Subject: Revised Responses to US-APWR DCD RAI No.744-5668 Revision 2 (SRP 19)

Revised Responses to Request for Additional Information
No.744-5668
Revision 2

US-APWR Design Certification

RAI NO.: NO. 744-5668 REVISION 2
SRP SECTION: 19 – Probabilistic Risk Assessment and Severe Accident Evaluation
APPLICATION SECTION: 19.1
DATE OF RAI ISSUE: 04/27/2011

Figure 1 Revised MCR Event Tree

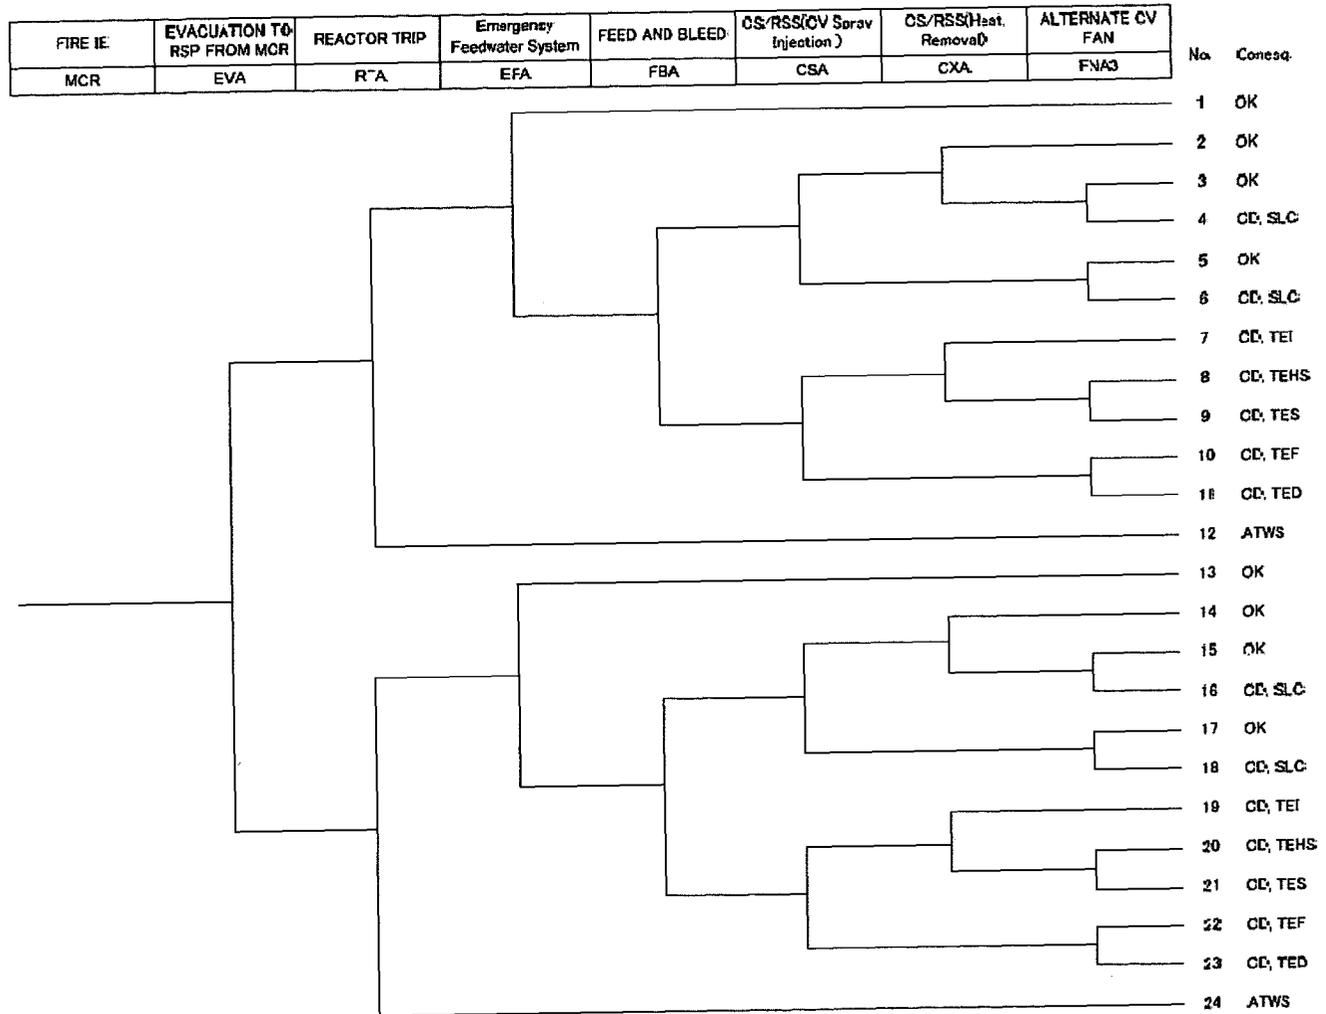
(Follow-up to Question 19-462) Please (a) describe in more detail and provide the failure probability of top event “EVA - Evacuation to RSP from MCR,” (b) provide the accident frequencies of main control room sequences shown in Figure 1, and (c) explain why both success and failure paths of top event EVA are identical.

(a) Description of top event “EVA - Evacuation to RSP from MCR”

(b) Accident frequencies of main control room sequences shown in Figure 1

Each sequence of the MCR event tree in Figure 1 is as follows. The accident frequencies are results from the internal fire PRA in DCD Revision 3. The fire PRA model is updated according to the internal event PRA model.

(c) Explanation for both the success and failure paths of top event EVA being identical

Figure 1 MCR event tree has been developed to quantify sequences for both operations at the MCR and at the RSC. The sequences of the event tree after the upper branch of top event "EVA" are for the MCR and the sequences after the lower branch of "EVA" are for the RSC. The success and failure

Although the same operation could be taken by the operators in the MCR and in the RSC, each human error probability of the operation from the safety VDU in the MCR and in the RSC is different. Because Bypassed or Inoperable Status Indication (BISI) information is displayed on the Large Display Panel (LDP) in the MCR as an alarm, operators in the MCR could easily recognize the plant abnormal condition and share the information. Additionally, because the Supervisor Console and the Shift Technical Advisor Console are also located in the MCR, the senior reactor operators (SRO) could easily hold the plant condition and actions which would be the responsibility of another reactor operator. However, it is more difficult for operators to recognize plant abnormal condition and to achieve recovery action by SRO in RSC room than in MCR because LDP or associated consoles are not installed in RSC room. Therefore, it is assumed that HEP of the operation in RSC room is higher than that in MCR. The human error of 0.1 is assumed to the operations from RSC that covers alternate shutdown means.
